- 4. Leisure time Estates Ivy Replat
KPB File 2022-130**

**PLAT OF
LEISURE TIME ESTATES IVY REPLAT**

ITEM 4 – LEISURE TIME ESTATE IVY REPLAT

STAFF REPORT

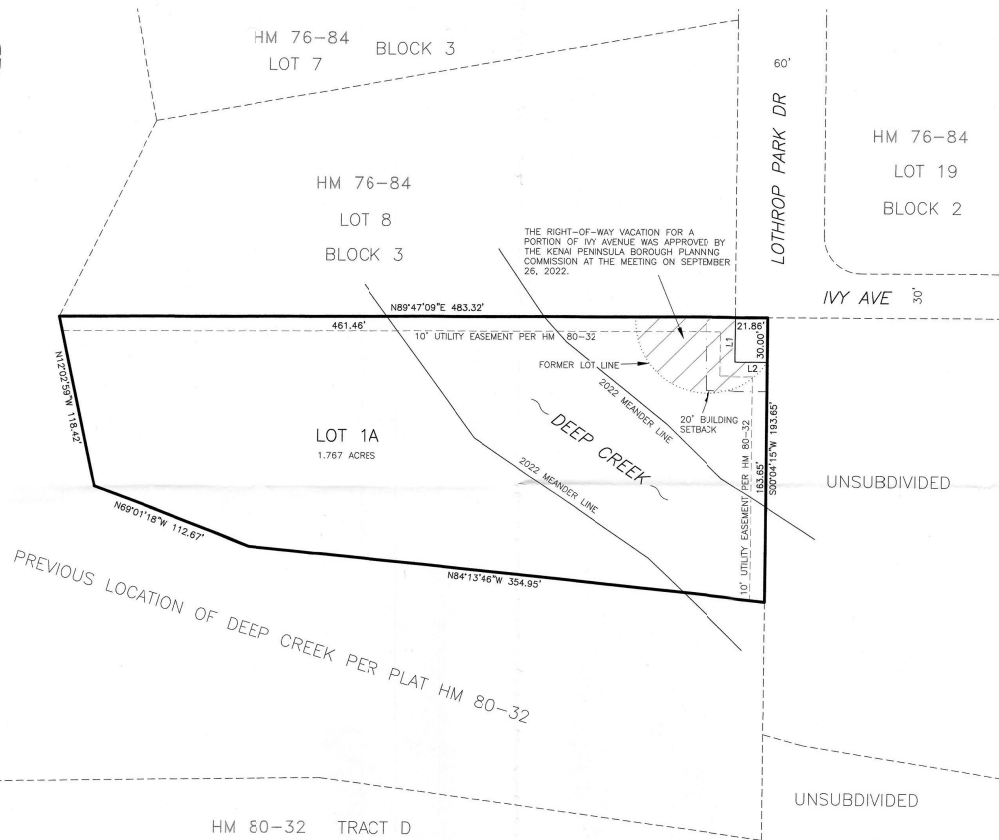
A label is provided for the vacation on the face of the plat. ***Staff recommends adding to the note the date the Assembly granted consent.***

There is a cabin and shed located on the property. The shed is completely within the right-of-way and the cabin has a portion within the cul-de-sac. The location of the cabin appears to be closer than allowed to the edge of Deep Creek. The owner has stated to staff that he has documentation that allowed the location. This is an issue to be reviewed by the River Center and KPB Code Compliance. The recording of this plat will resolve the encroachments within the right-of-way. A new setback and utility easement will be granted along the new right-of-way edge. **Staff recommends the surveyor verify if any improvements will be within the setback or utility easement and if so, they should be depicted and additional plat notes will be required to show they are exempt to the setback/utility easement.**

The entire preliminary plat is considered wetlands with a Riverine designation. **Staff recommends a wetland determination plat note be added to the plat.**

The 2022 meander lines for Deep Creek are shown on the plat. **Staff recommends the source or method for determining the meander lines should be noted or labeled.**

The certificate to plat indicates an easement has been granted. The document provides the location for the easement. **Staff recommends the surveyor review the easement and determine if it applies to this property and provide a note with recording information if it does apply.**

Staff suggests that plat note 1 be split so that one note deals with the setback and another with the utility easements. The utility easement note could be combined with note 2 if desired. Due to the design of the utility easements along the north and east, the statement about 20 feet within 5 feet of the side lot line is not required. **Staff recommends the note regarding utility easements be revised, "The front 10 foot adjacent to dedicated rights-of-way is a utility easement granted by this plat. This plat will also be granting 10 foot utility easements along the boundary within the vacated area to provide continuations of the previously granted 10 foot utility easements."**

There is an easement issued by recorded document to Homer Electric Association. The easement refers to a specific transmission line but no specific location. **Staff recommends a plat note with the easement information be added unless it can be shown to staff that it does not apply to the subject property.**

Staff recommendation: Include SE1/4 in location description.

- J. Block and lot numbering per KPB 20.60.140, approximate dimensions and total numbers of proposed lots;
Staff recommendation: Add a block label to the lot to carry over the designation.

Staff recommendation: Due to the restraints created by Deep Creek and the minimal access to dedicated right-of-way a plat note should be added "There are possible limitations on further subdivision based on access issues, development trends in the area, or topography."

Staff recommendation: In addition to the overall acreage provide the acreage for dry area and submerged land. Provide boundary and lot closure computations with the paper final plat. KPB will verify closure complies with 20.60.120.

- *This is a paper plat. A field survey was not performed.*
- *Any person developing the property is responsible for obtaining all required local, state, and federal permits, including a U.S. Army Corps of Engineers wetland determination if applicable.*
- *There are possible limitations on further subdivision based on access issues, development trends in the area, or topography.*
- *Subject to a right-of-way easement to Homer Electric Association Incorporation within Serial 2019-000154-0, HRD.*
- *The natural meanders of ordinary high water is for area computations only, the true corners being on the extension of the sidelines and the intersection with the natural meanders.*
